# PLANNING COMMISSION FINAL REPORT

Case No. 0321-01

**TECHNICAL REVIEW COMMITTEE (TRC) PLAT REVIEW COMMENTS**

**The Portside PUD**

THE PORTSIDE P.U.D.  
MASTER SITE PLAN  
EXHIBIT 2

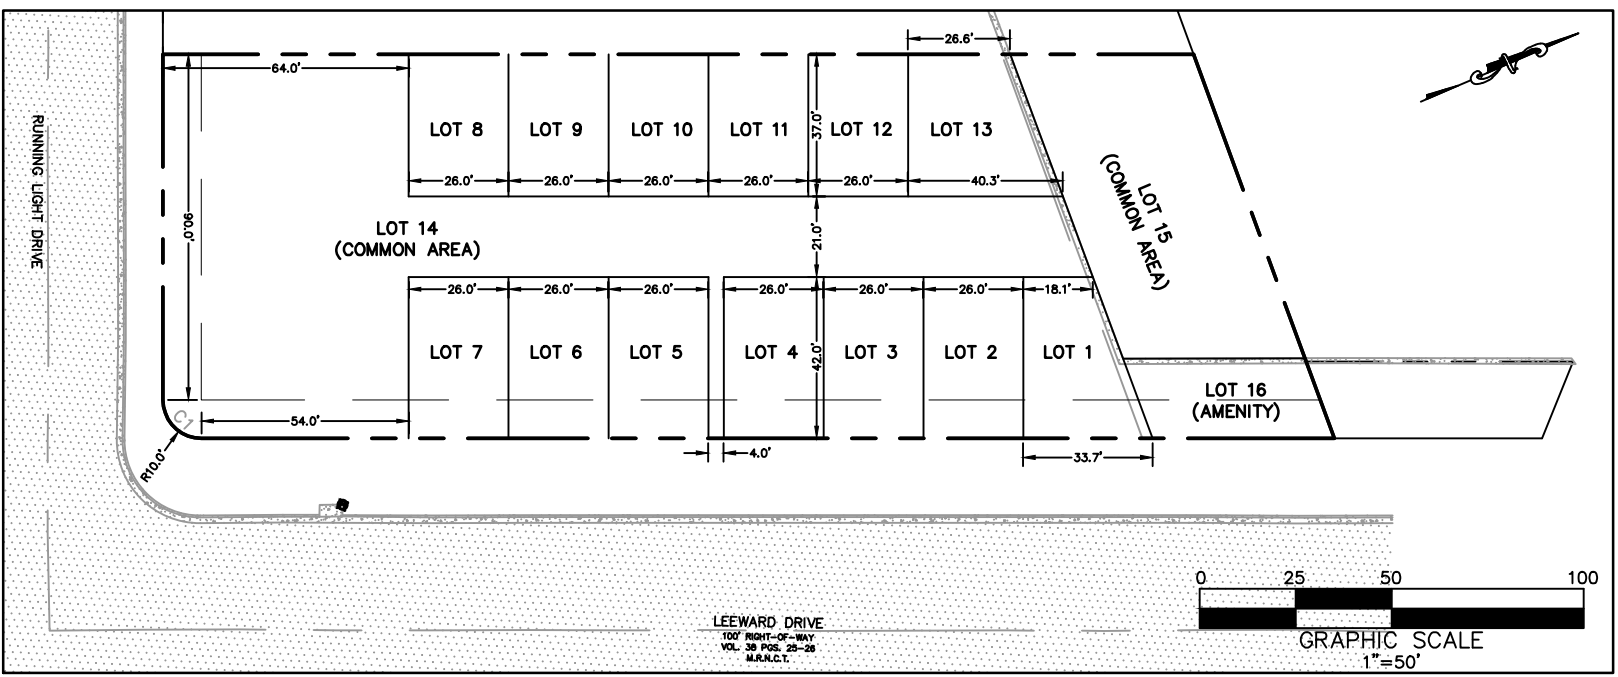
<b>ZONING</b>						
No.	Sheet	Comment	Applicant Response	Staff Resolution	Applicant Response	Staff Resolution
1	PUD	Sidewalks shall be constructed along Running Light Drive and Leeward Drive. This comment will be also cited at the platting stage.	To be addressed at platting stage

<b>PLANNING/Environment &amp; Strategic Initiatives (ESI)</b>						
No.	Sheet	Comment	Applicant Response	Staff Resolution	Applicant Response	Staff Resolution
1	PUD	Was this lot(s) granted a sidewalk waiver in the past?; driveway should take access from Running Light and should be further from the intersection; will there be an HOA to maintain; guest parking on Running Light rather than Leeward?; will 3 golf card parking spaces be enough for 13 units, which spaces are they on the drawing?; will landscaping or screening walls be used as a screen for the parking lot?; show on-street parking guest spaces provided.	No previous sidewalk waiver to our knowledge; Driveway access relocated to Running Light furthest possible from intersection; Yes there will be an HOA, Guest parking allowed on both leeward and Running Light, but Leeward used for parking tabulation due to larger frontage; Golf cart spaces relocated; landscaping and screening proposed between parking lot and public sidewalk; on-street parking area delineated on Master Site Plan.

<b>UTILITIES ENGINEERING</b>						
No.	Sheet	Comment	Applicant Response	Staff Resolution	Applicant Response	Staff Resolution
1	PUD	Point of Notice – It appears that an insufficient amount of water flow for fire protection is available at this location for this development, and improvements may be required if platted.	Assume this comment to be informational. Public water main construction proposed with platting

1		Proposed driveway access to a public City Street shall conform to access management standards outlined in Article 7 of the UDC. Review the driveway as it is to close to the intersection as generally you need a buffer, so northbound vehicles can make the left turn passing the intersection and not block the intersection.	Driveway access revised.			
---	--	--	--------------------------	--	--	--

No.	Sheet	Comment	Applicant Response	Staff Resolution	Applicant Response	Staff Resolution
1	PUD	Water Distribution Standards: If the property use is commercial, the fire flow requirements shall be a minimum of 1,500 GPM at 20 PSI residual. With hydrant spacing every 300 feet. If the property use is residential, the fire flow requirements shall be a minimum of 750 GPM with 20 psi residual. With hydrant spacing every 600 feet. The requirement for each shall be resolved at the Development Service or Building phase of the project. Exception: For buildings equipped with an approved automatic sprinkler system, the distance requirement shall	Noted. Property use to be residential.			
2	PUD	D102.1 Access and loading. Facilities, buildings, or portions of buildings hereafter constructed shall be accessible to fire department apparatus by way of an approved fire apparatus access road with an asphalt, concrete or other approved driving surface capable of supporting the imposed load of fire apparatus weighing at least 75,000 pounds.	Noted.

3	PUD	503.2.1 Dimensions. Fire apparatus access roads shall have an unobstructed width of not less than 20 feet, exclusive of shoulders and an unobstructed vertical clearance of not less than 13 feet 6 inches. Note: the entry point will require fire department access.	Noted.			
4	PUD	503.4 Obstruction of fire apparatus access roads. Fire apparatus access roads shall not be obstructed in any manner, including the parking of vehicles.	Noted.			
5	PUD	503.3 Marking: Where required by the fire code official, approved signs, or other approved notices the include the words NO PARKING-FIRE LANE shall be provided for fire apparatus access roads to identify such roads to prohibit the obstruction thereof. The designation of a fire lane can be marked with conspicuous signs which have the words:” Fire Lane-No Parking” at 50-foot intervals. In lieu of signs, fire lanes may be marked along curbing with the wording, “Fire Lane-No Parking” at 15-foot intervals.	Noted.

6	PUD	<p>Development of the property will require further Development Services review. Note: The minimum separation distance between cottages is 10 feet. Due to the proximity of the cottages, Development Services may not approve of this configuration.</p> <p>Note: The side gate on Leeward St. will allow 150 feet to farthest point of the cottages toward the dock and will be considered suitable as an access point for firefighting efforts. If the gate is secured, a Knox Padlock will be required.</p> <p>Note: If the dock is constructed with the capability for</p>	<p>Review of proposed building placement is required at this stage as layout is tied to PUD conditions. Cottages are proposed with 8-foot separation in accordance with UDC 4.7.11. Construction will comply with International Residential Code and current fire code as required by City.</p>			
---	-----	---	---	--	--	--

No.	Sheet	Comment	Applicant Response	Staff Resolution	Applicant Response	Staff Resolution
1	PUD	AEP is requesting the 10YR to be a 10YR/EE off of Running Light	To be addressed at platting stage.
